## 2022.12 Mass production inspection

Model Name: BFX-AT100

Document Version: ALT\_STB\_MP\_CSMTINS\_001

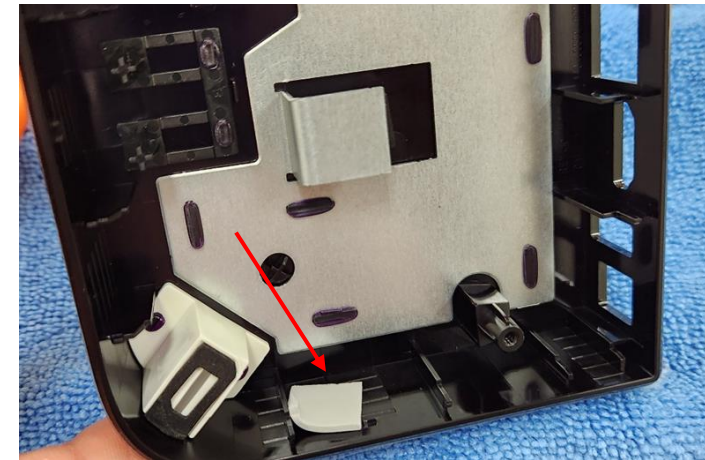
- Issue grade : Major
  - Defect carton Q'ty : 1pcs / 1600pcs
  - SN : 2149688001202201444939
- Symptom
  - Shaking the product makes noise
  - <https://drive.google.com/file/d/1PainSPbfJ0vBBTgDBf-MMBxRtaZnHCl0/view?usp=sharing>
- ALT initial review
  - Checked exterior cosmetic : No found abnormal
  - Disassemble STB : Found abnormal
    - The thermal pad was detached
    - ALT was assembled again.
- Action item
  - FXN should be submit 8D report
    - Find the root cause : Add a detection process
    - Provide the preventive action
